11.1.16 Proposed Concrete Batching Plant - Amended Plans to Approved Application - Section 31 SAT Reconsideration

Location: Lot 2, 277-279 Collier Road, Bayswater
Applicant: WA Limestone
Owner: Ransberg Pty Ltd
Officer: Director Planning and Development Services
Refer: Item 11.1.10: OCM 25.8.2015
 Item 11.1.10: OCM 26.5.2015
 Item 11.1.12: OCM 23.7.2013
 Item 11.1.10: OCM 23.4.2013
 Item 15.1.3: OCM 22.11.2011
 Item 11.1.12: OCM 28.6.2011

**Proposed concrete batching plant - WA Premix
SAT mediation - updated advice on environmental risks**

Plans for Development - Amended

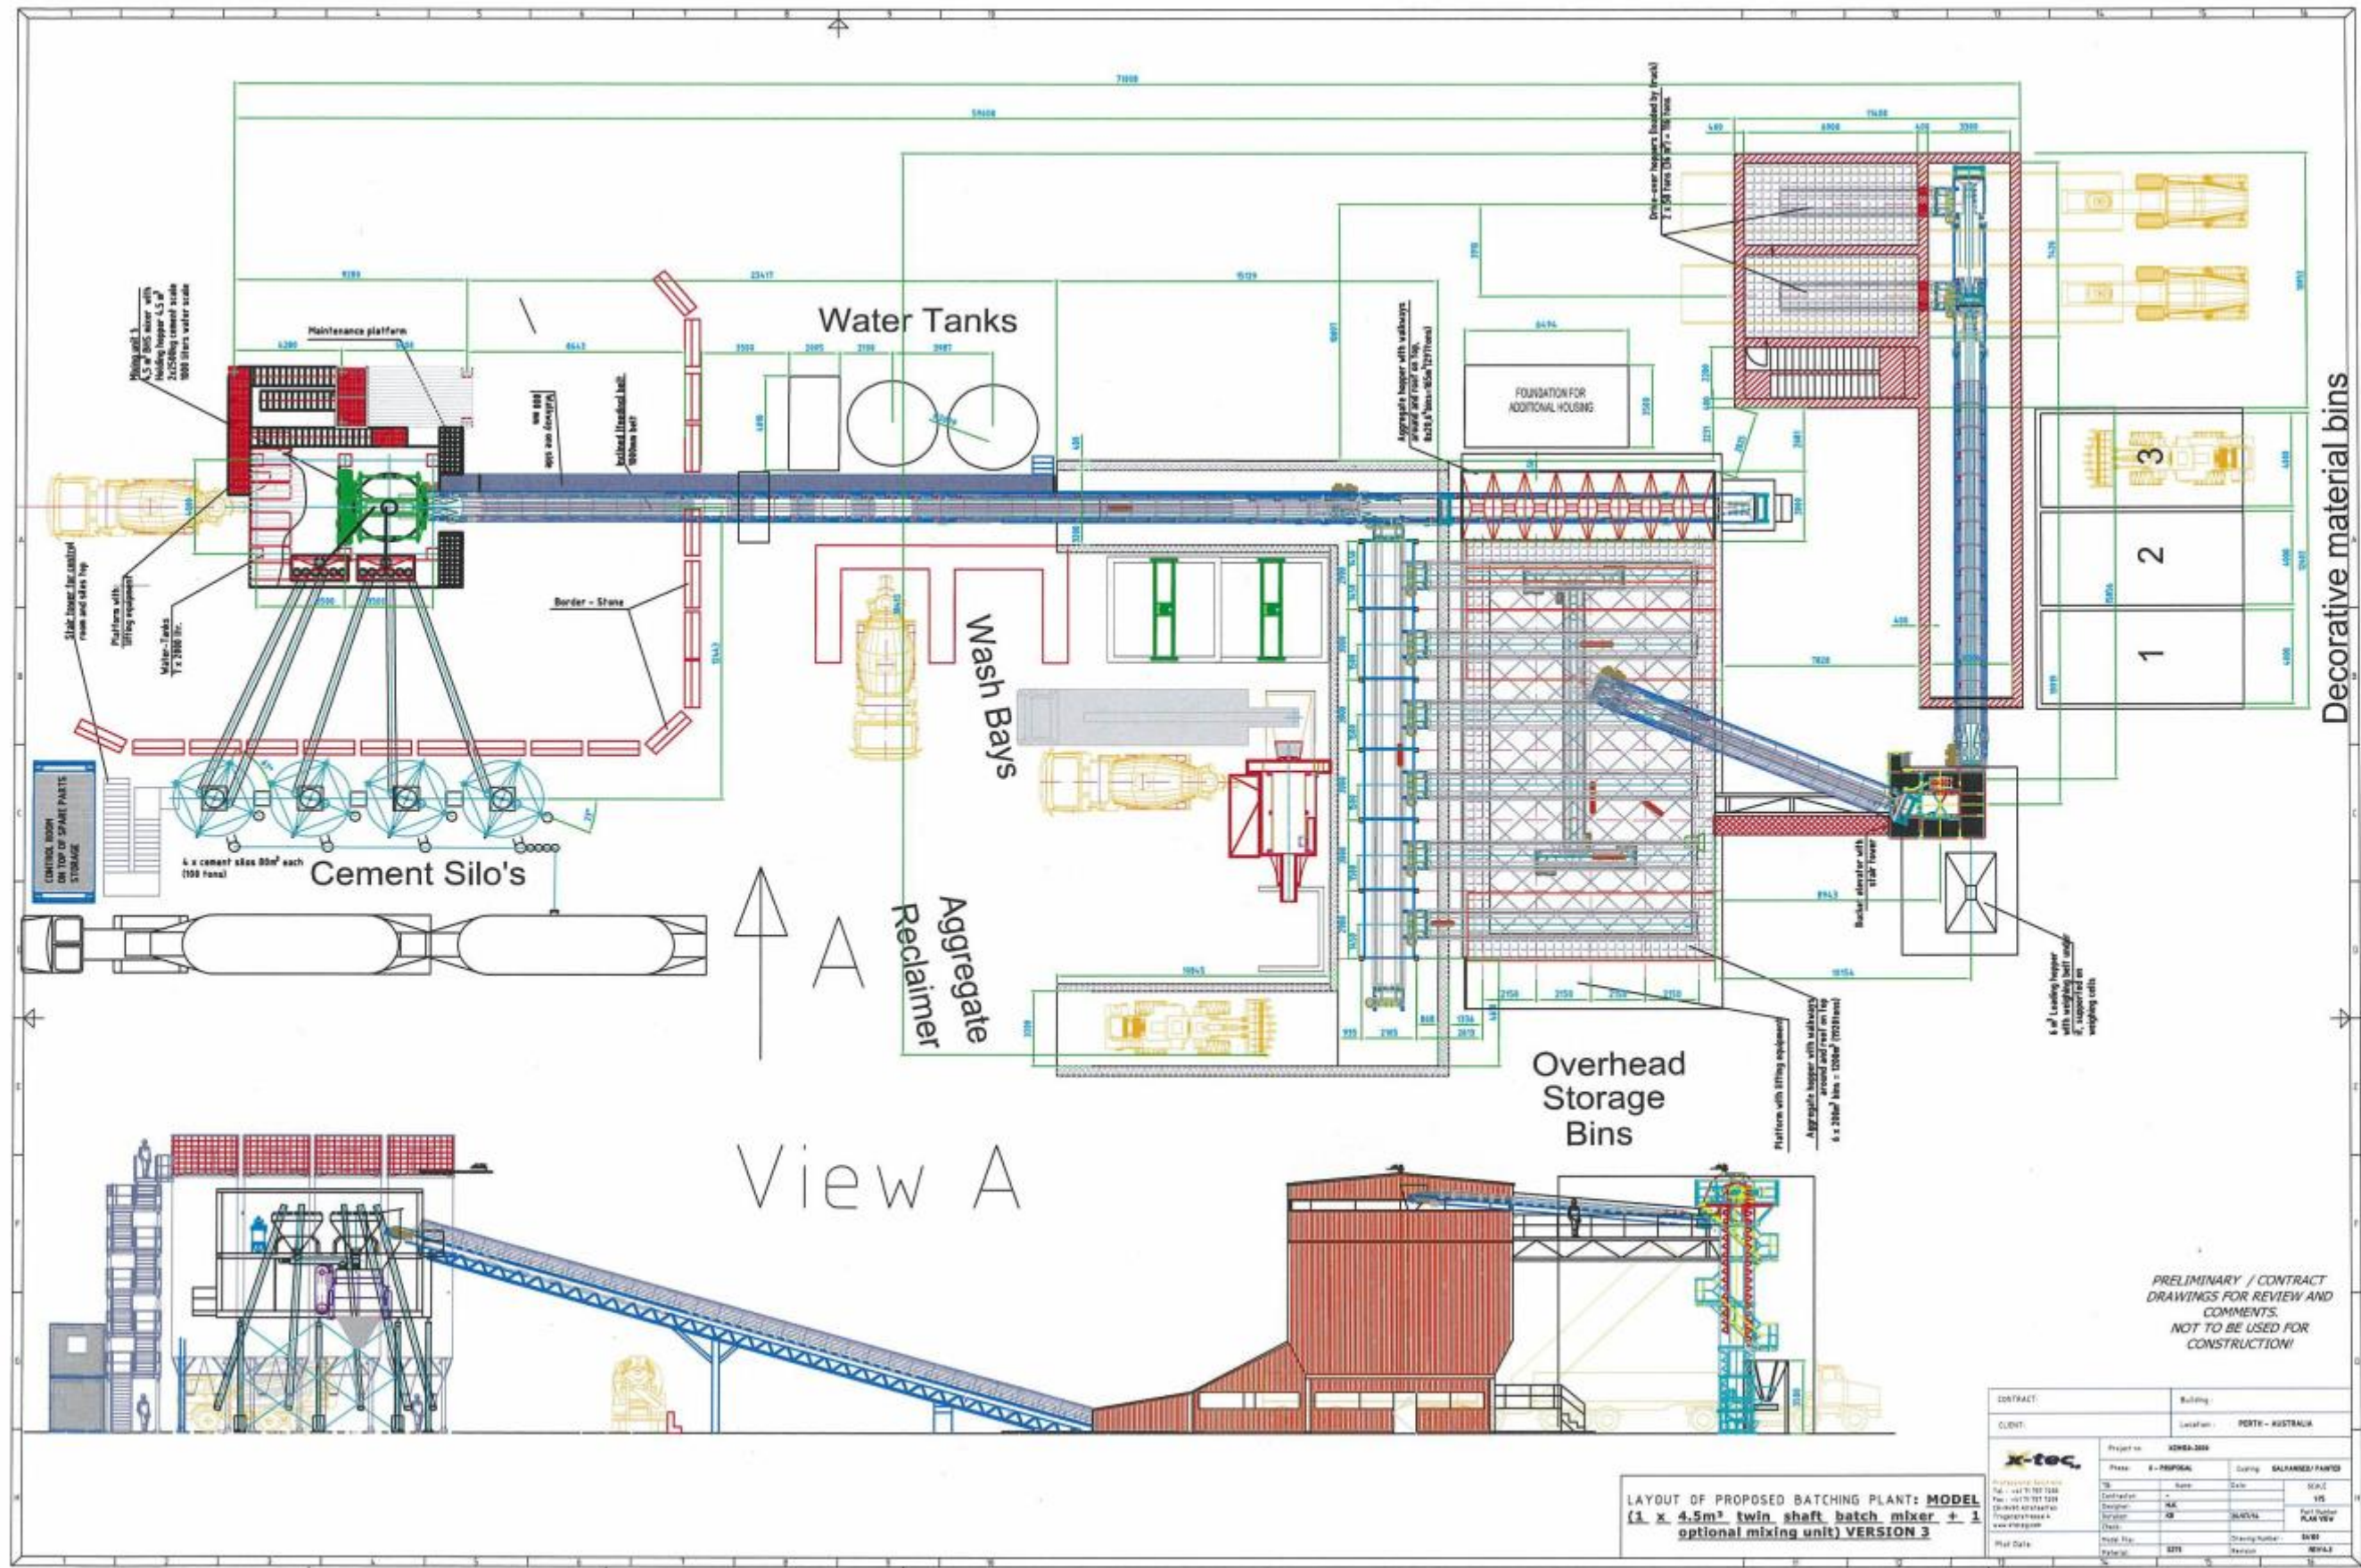
The applicant has advised that the amended application proposes to enclose the plant with the exception of the wash bay, and that the wash bay will not generate dust (**Attachment 7**).

The City's environmental consultant considers that amended proposal will have a lesser environmental impact than the plant originally approved by the SAT. The amended plans illustrate the wet-mix plant will be mostly enclosed and by this, will substantially decrease risks of noise and dust emissions. The environmental report supplied by the applicant states:

The proposed alterations are considered to improve the applicant's ability to manage dust and noise emissions from the site, given the plant will be mostly enclosed. The amended plans will essentially eliminate the consistent use of front-end loaders which is considered to substantially lower any potential noise impacts.

That Council, in consideration of the additional information provided by the applicant and environmental consultant, approves the revised plans dated 29 January 2015 in relation to the planning approval granted by the State Administrative Tribunal on 15 July 2015 for the proposed concrete batching plant at Lot 2, Nos. 277-279 Collier Road, Bayswater, subject to all conditions and requirements detailed on the previous approval granted 15 July 2014 and the following amended and additional planning conditions:
